ADDENDUM NO. 2

**Parking Lot Repairs
Fulton Treatment Center
Fulton, Missouri
PROJECT NO. H2501-01**

June 25, 2026

SHEET TITLE:
SITE CIVIL DETAILS

A ASPHALT PAVEMENT
NOT TO SCALE

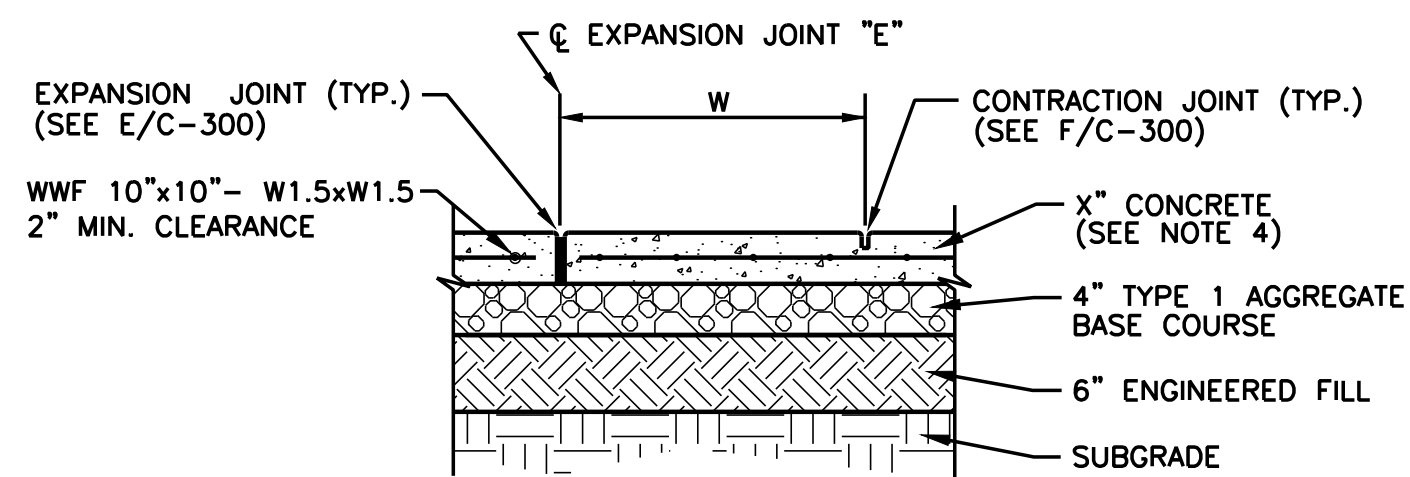
1. C-201 – REVISED Keynote 1 to state: Cold Mill 2-inches deep, seal visible cracks in milled surface, and overlay 3.5-inches surface course pavement in accordance with Detail A/C-300. Match existing crown of roadway to prevent ponding. Maintain minimum of 1% slope on all new pavement.
2. C-202 – REVISED Keynote 1 to state: Cold Mill 2-inches deep, seal visible cracks in milled surface, and overlay 3.5-inches surface course pavement in accordance with Detail A/C-300. Match existing crown of roadway to prevent ponding. Maintain minimum of 1% slope on all new pavement.
3. C-300 – REPLACE sheet in its entirety.
